TEXAS COMMISSION ON ENVIRONMENTAL QUALITY
Protecting Texas by Reducing and Preventing Pollution

Re: Dam Safety Complaint Inspection Report for Lake Dodge Dam (TX05265)
Montgomery County, Texas

DAM SAFETY INSPECTION REPORT

DAM: Lake Dodge Dam

Photo 15: View of the service spillway channel entrance (lines), from its right/upstream corner, facing downstream (southeast). Note that the channel is almost obscured by brush, trees, and debris.

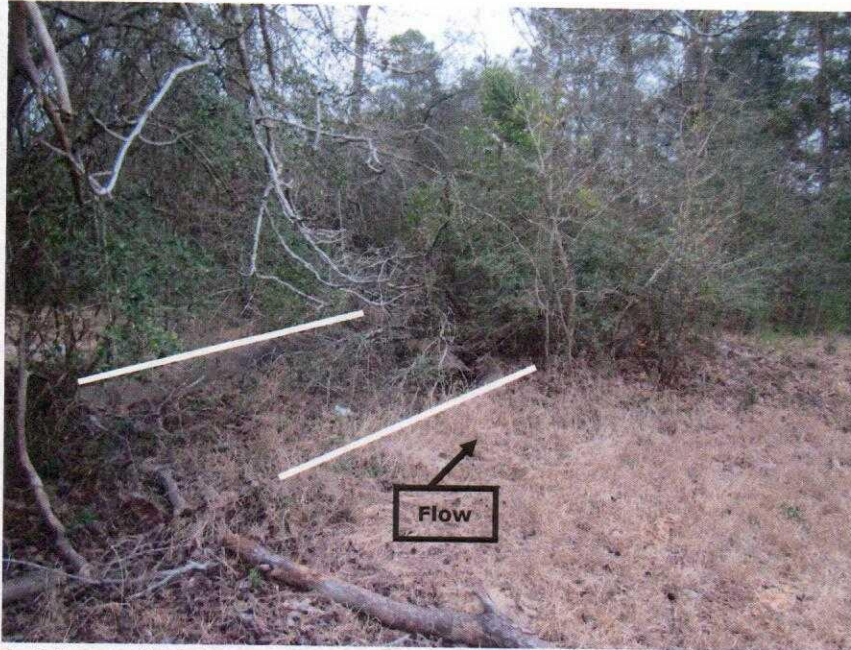
- The service spillway is located at the left end of the dam.
- The service spillway consists of a concrete channel 8-ft. wide and 1-ft. deep that discharges into a natural channel.
- Most of the service spillway was obscured due to tree and brush growth. The visible portions of the service spillway had trees, brush, leafy debris, and downed trees within the channel that could impede flow away from the dam.
- The service spillway was found to be in poor condition due to the debris and vegetative growth obstructing the channel.

5. All trees (regardless of size), brush, and excessive vegetation should be removed from within the service and emergency spillways and their discharge channels to ensure adequate flow conveyance. The leafy debris and downed trees in the service spillway channel should also be removed.

For any larger/mature trees immediately adjacent to the concrete service spillway channel, it may be preferred to cut the tree and leave the stump in place, if removal of the root ball would cause damage/movement to the concrete channel. Any remaining stumps should be treated with a sealant to inhibit/prolong decay. Once cleared, a P.E. should inspect the spillways for any defects that may have been hidden by the trees and overgrown vegetation. Depending on the results of the inspection, the P.E. should design and oversee any necessary repairs or modifications to the spillway(s). TCEQ Dam Safety must review and approve any and all construction plans and technical specifications before construction may begin.
